Montex Fabrics Ltd

DEA

Structural Inspection Report

Observations & Actions

Recommendation of DEA report

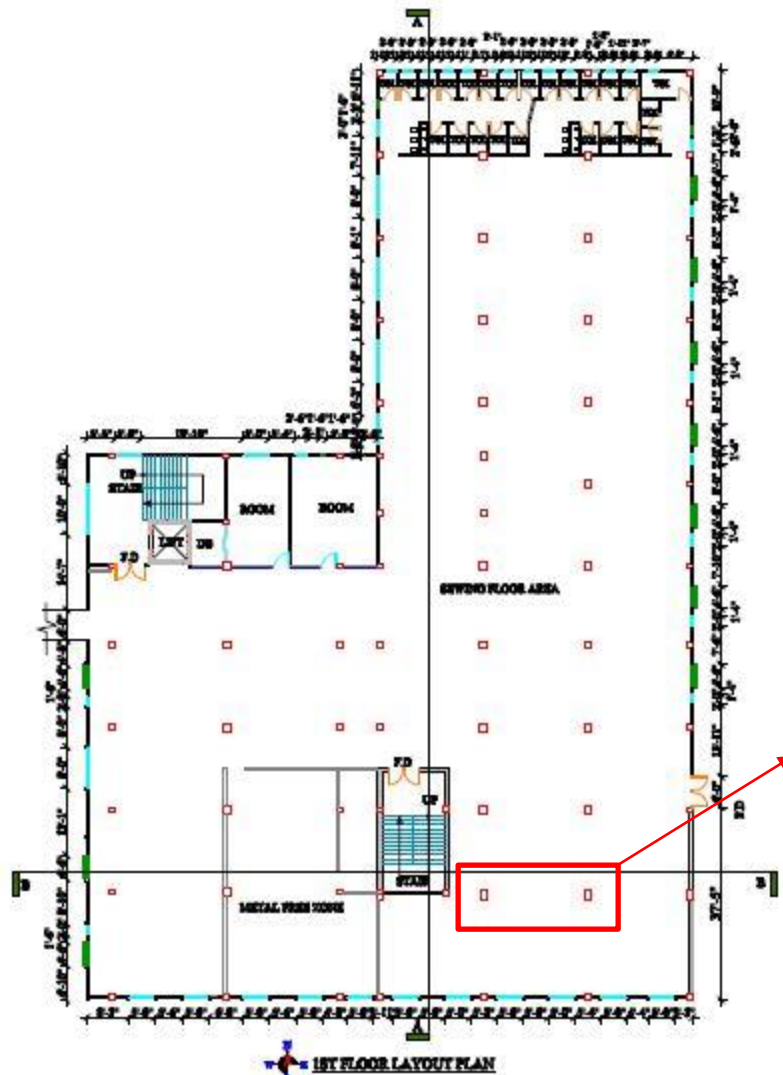
Therefore, the entire structural elements are inadequate under BNBC-2006 standard loading condition (3 KN/m²). Retrofitting of few Columns and Footings are required.

As per DEA recommendation foundations are inadequate due to punching shear and bearing pressure. Columns are also inadequate. Retrofitting suggested to the inadequate members.

Recommendation: No Vertical extension is allowed.

1st floor layout plan

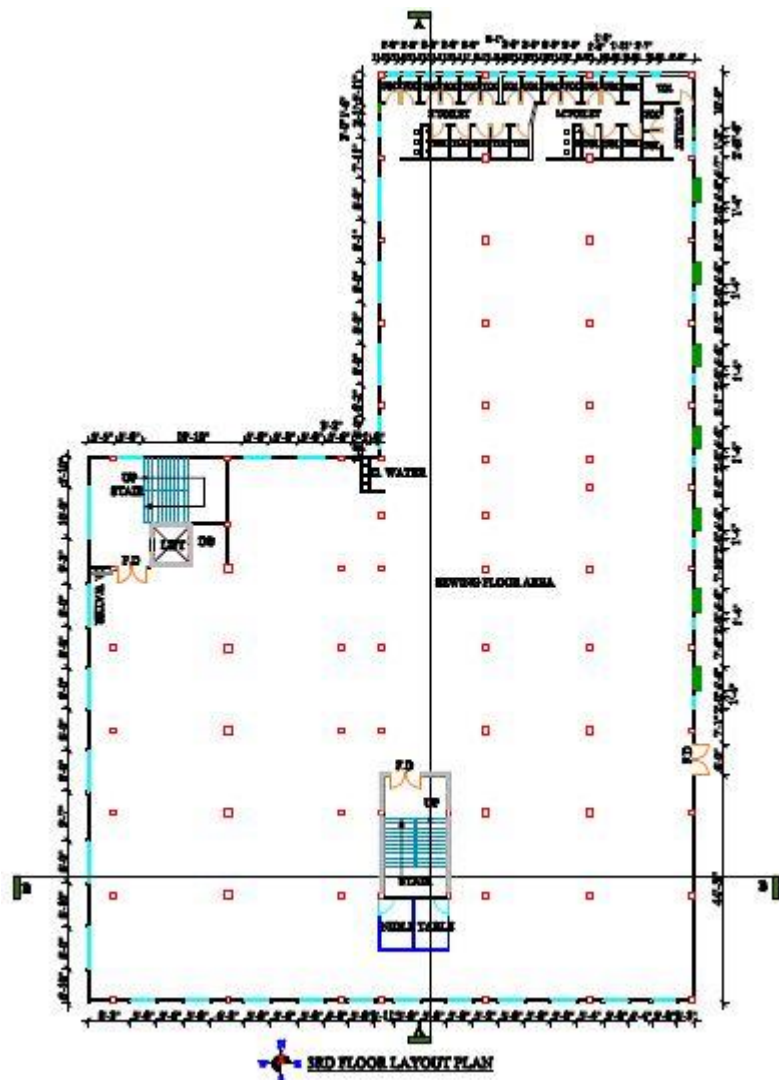
Cracks were observed on beam-column joint. Building engineer is required to investigate the cracks and carry out suitable repair work as per recommendation of investigation report.

Discrepancies in as-built drawings

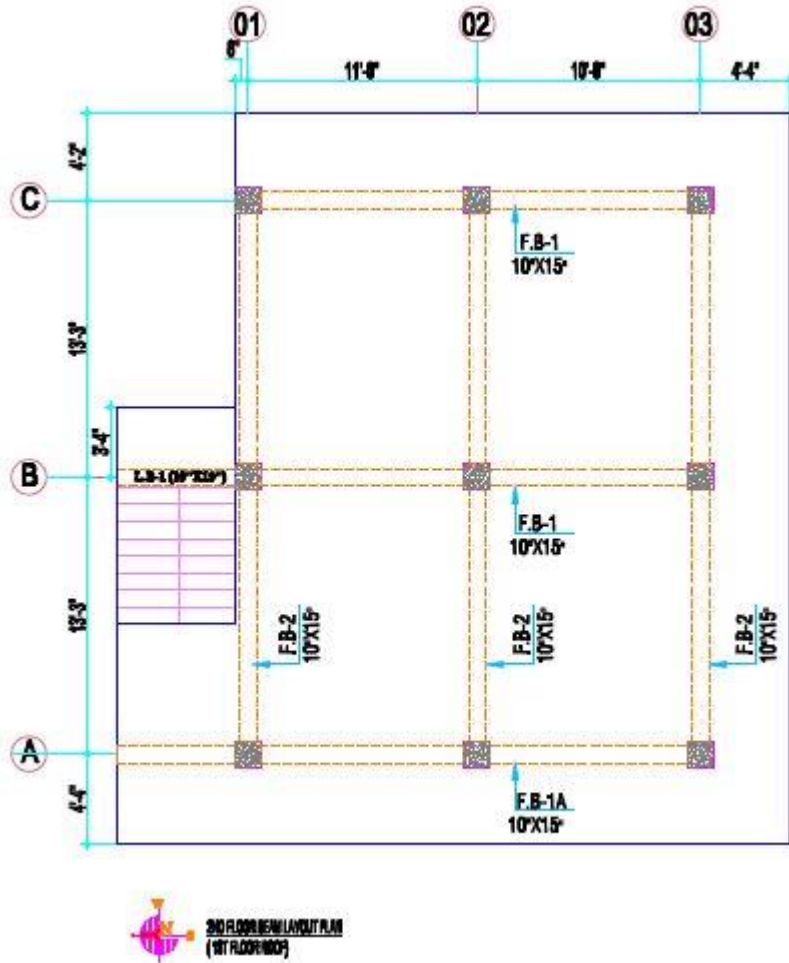
As per column schedule all rebars are 22 mm diameter but onsite some of the rebars were found 20 mm & 16 mm diameter.

Down stand of the beam was measured 150 mm, but drawings shows 235 mm.

COLUMN LAYOUT PLAN

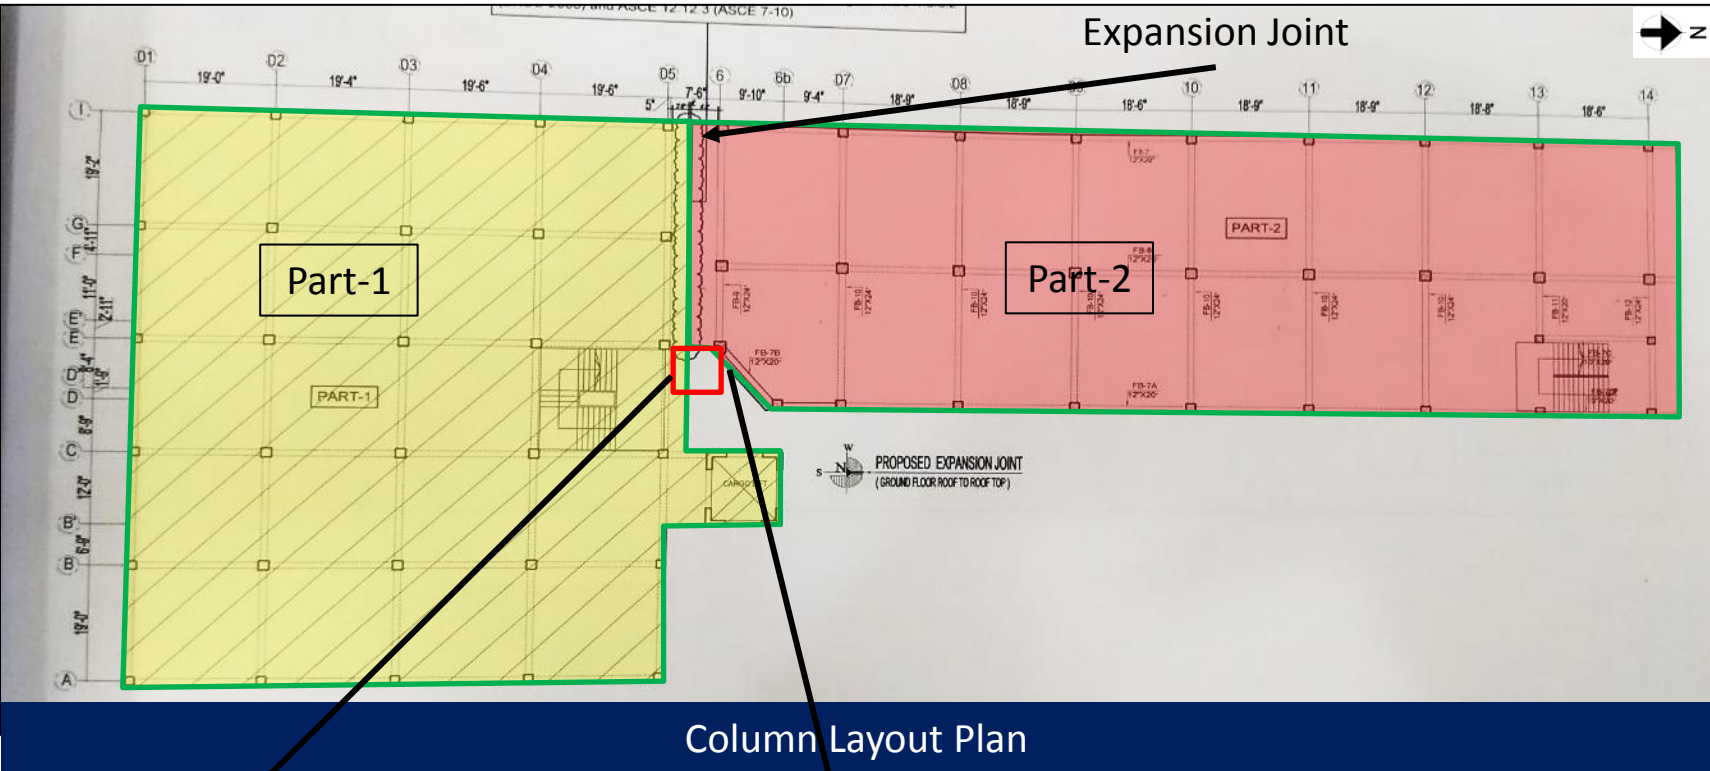
Observed live load more than 2 kPa

Preliminary calculations indicate high stresses in the columns based on the concrete strength (from core test report) and observed load plan. Moreover, as per the provided DEA report, most of the columns are inadequate and column strengthening has been suggested. The building engineer is required to review design, load & column stresses in the areas identified above as per building code.

Non-engineered shed at roof

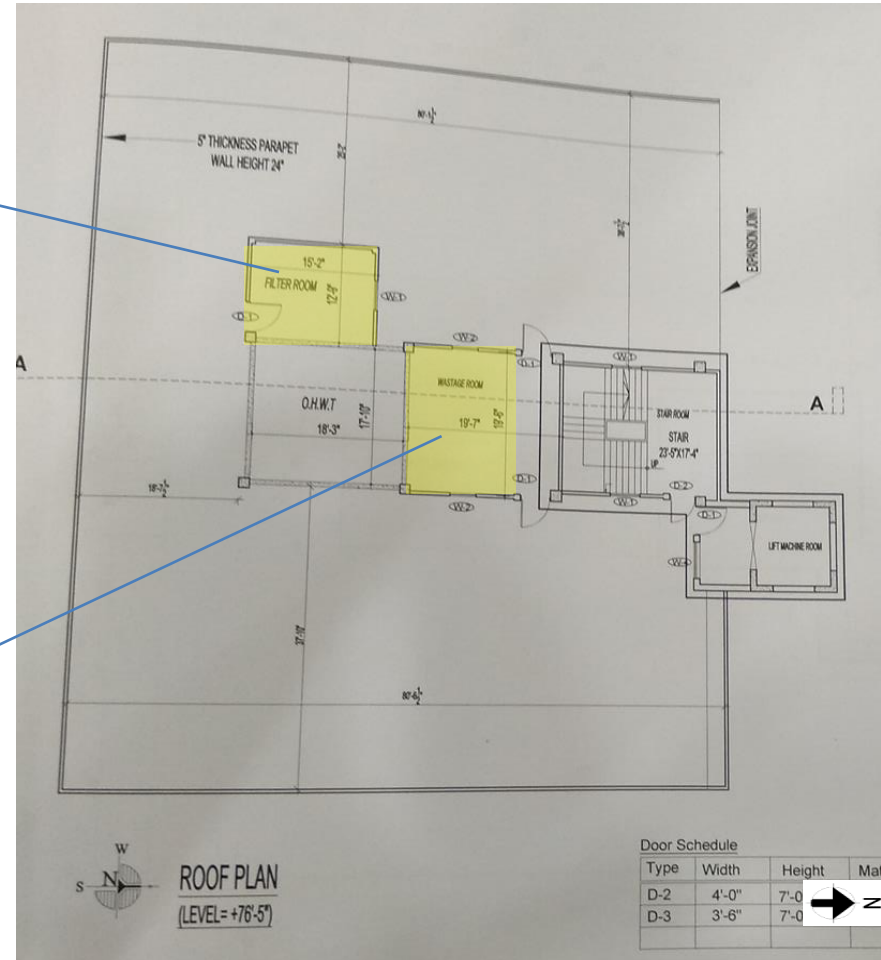
Rafter supported on brick wall

Truss supported on brick wall

Non-engineered shed was found at roof level.
The connections of the truss/rafter with wall are non-engineered.

- Building engineer to check the connection & capacity of the lightweight roof structure against lateral loading.
- Or replace the existing shed with an engineered structure.

Columns to be stressed above normal design limits

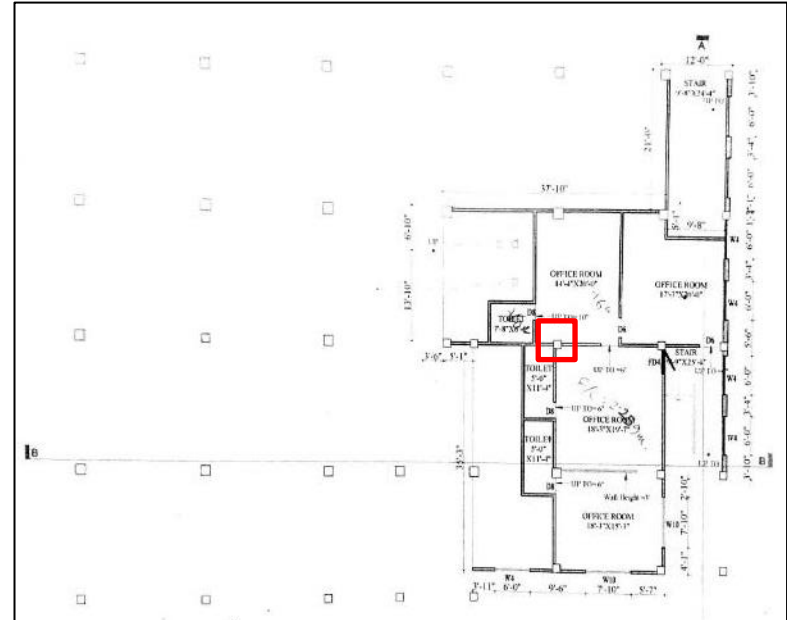
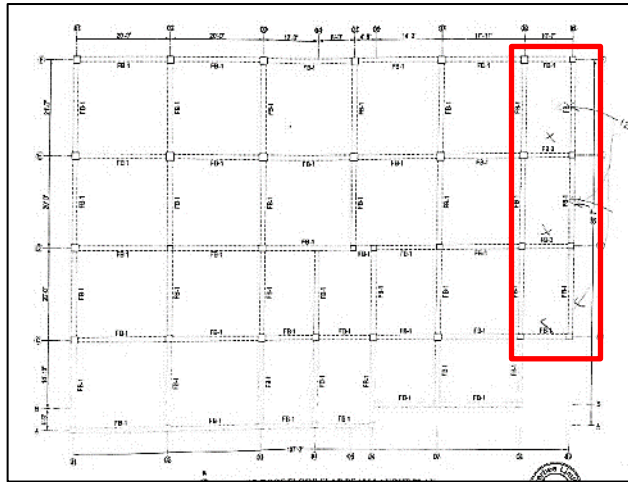
Cursory Calculation indicate that the working stress of the highlighted column at ground floor level appear to be stressed in excess of normal design limits

- Factory Engineer to review design, loads and columns stresses in area identified in observations.
- Verify in situ concrete stresses either by 100mm dia. cores or existing cylinder strength data for [the identified columns] or [100mm dia. cores from 4 columns].

2nd floor beam layout

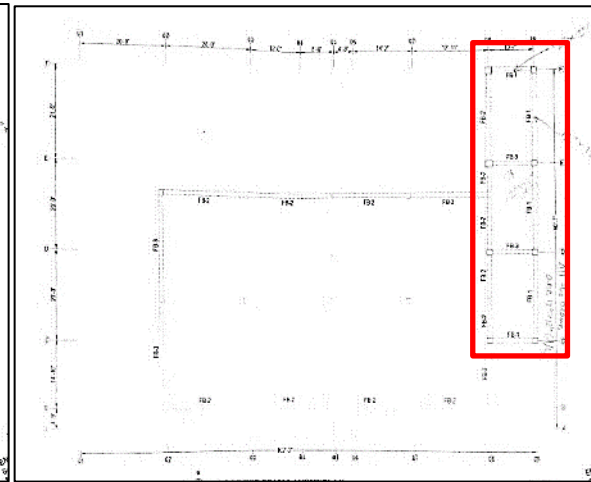
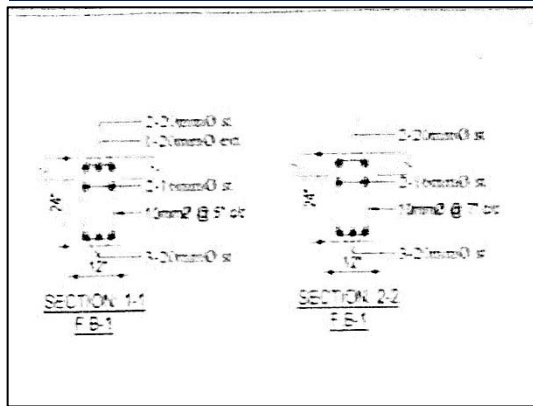
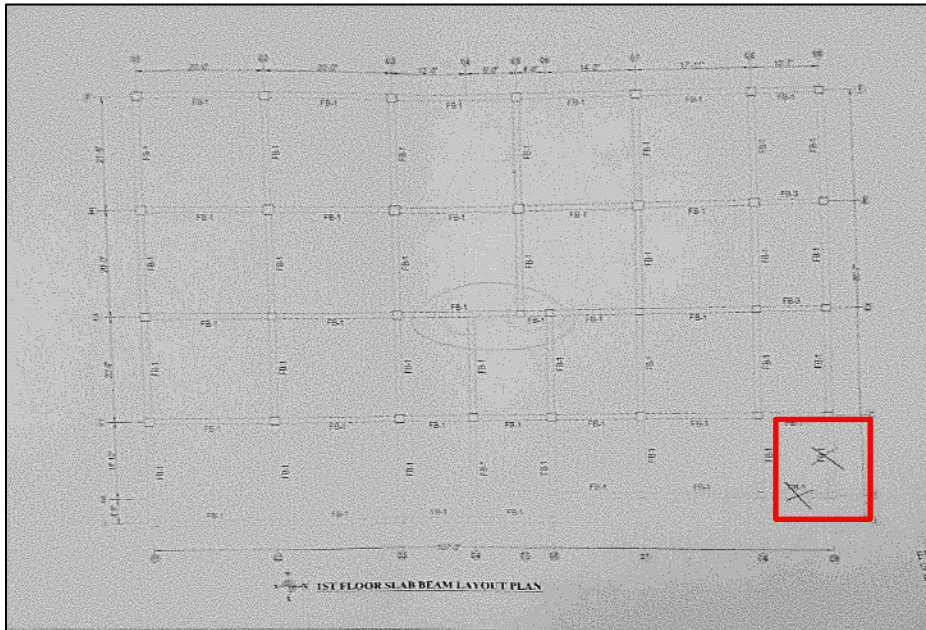
In the marked area of 2nd floor and roof, the down-stand of beam was measured 300 mm whereas as per drawings it should have been 450 mm (18 inches). Also, beam (FB-3) in the 2nd floor marked area were missing.

1st floor beam layout

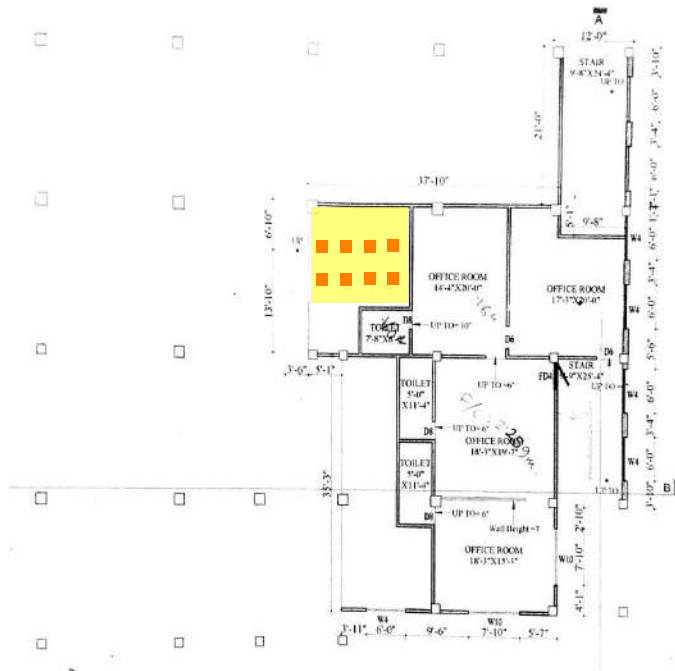
Marked beams in the 1st floor beam layout were missing

Undocumented mezzanine floor

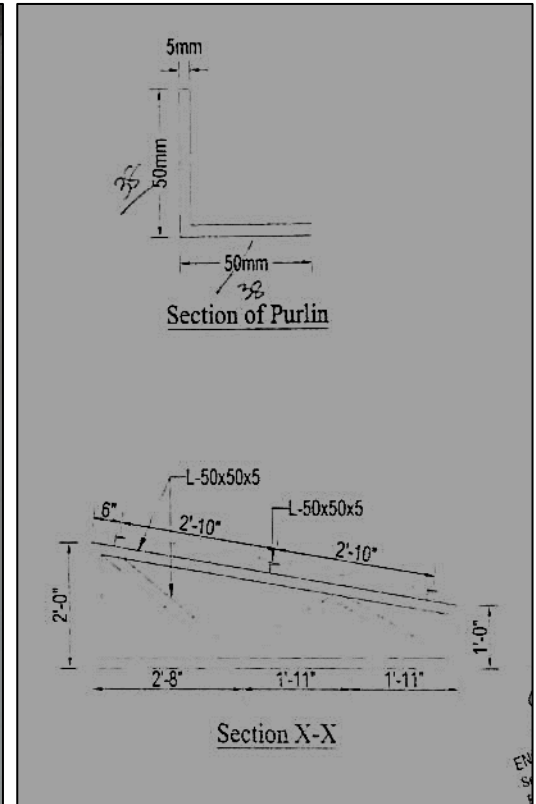
An undocumented RC mezzanine floor portion was observed in between ground floor and 1st floor. Foundation details of additional columns are unknown.

As per the drawing, the angles in canopy are supposed to be 50 mm but during inspection, angles were measured 38 mm.

Non-engineered rooftop Shed

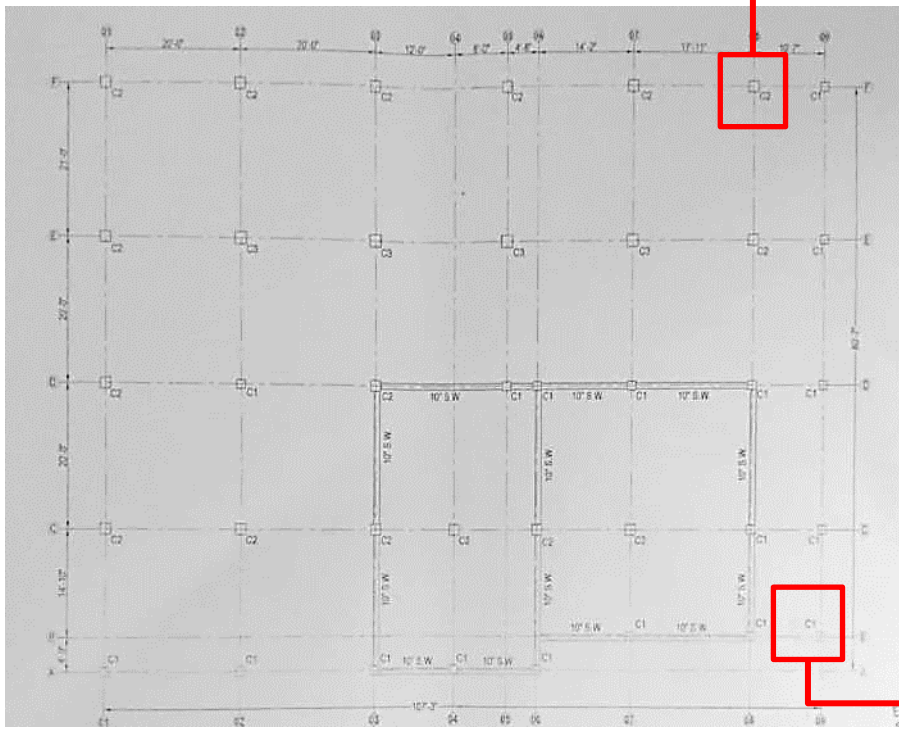
There is a rooftop shed on top of the building which is undocumented. The roof trusses are constructed with rebars and angles. Also As per as built drawings, the rooftop shed is required to be demolished but on site rooftop shed was found intact.

Column Layout

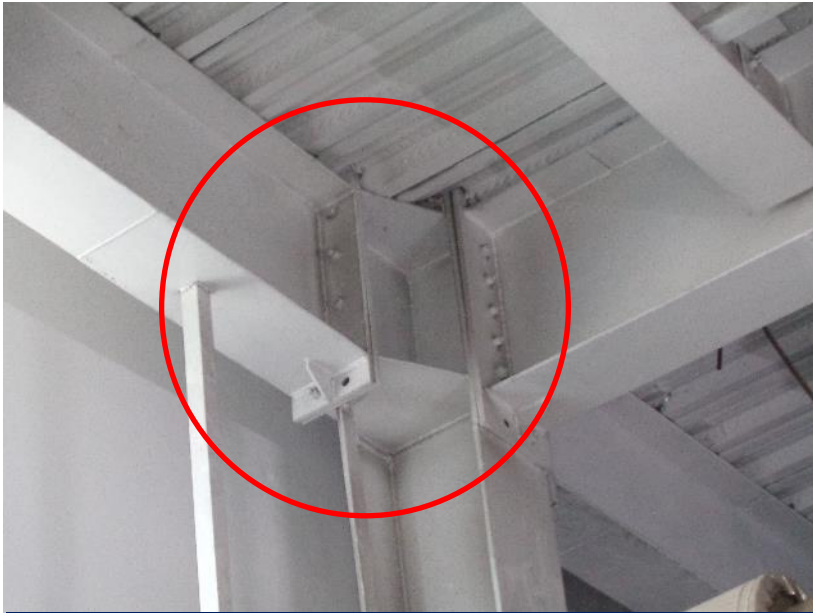
Column on Grid F-8 in the 2nd floor was found damaged due to fire door installation. Also, Column on grid B-09 in the ground floor was found damaged.

Bolt missing in connection

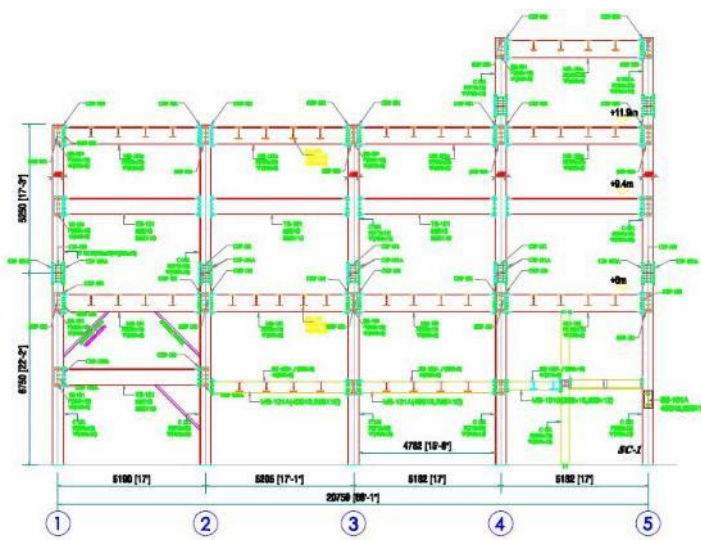
Bolts were missing in several location of the building. Building engineer is required to identified the location and reinstall the missing bolts as per specification.

Irregular bracing system

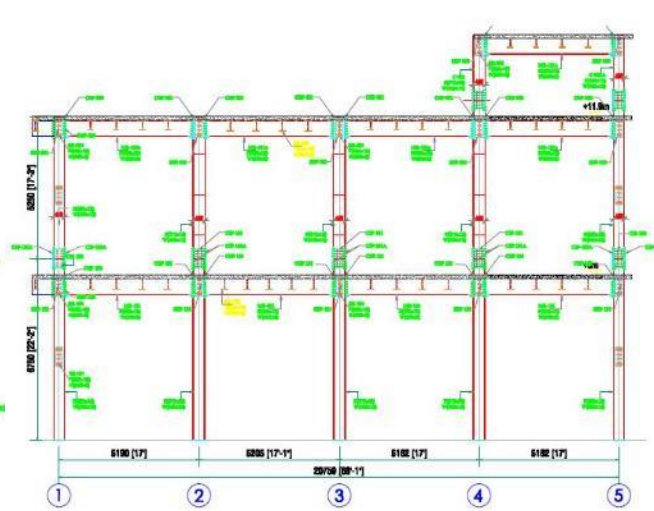
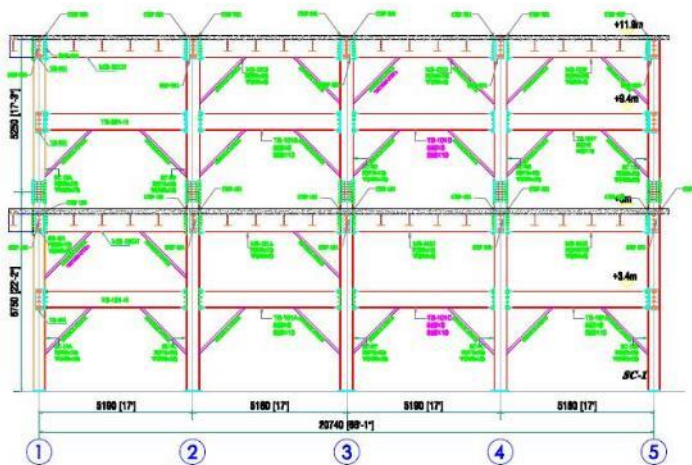
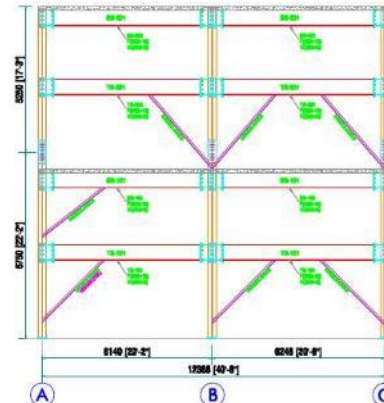
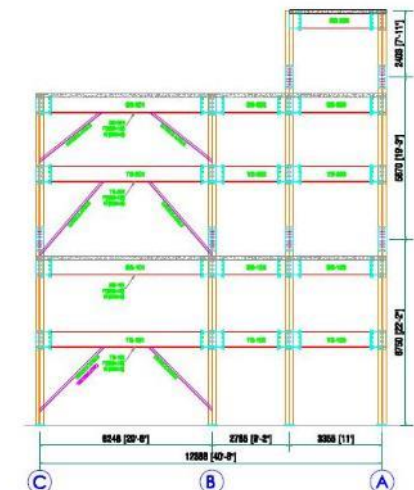
Irregular bracing system observed in the building. Building engineer is required check the existing bracing system for lateral stability.
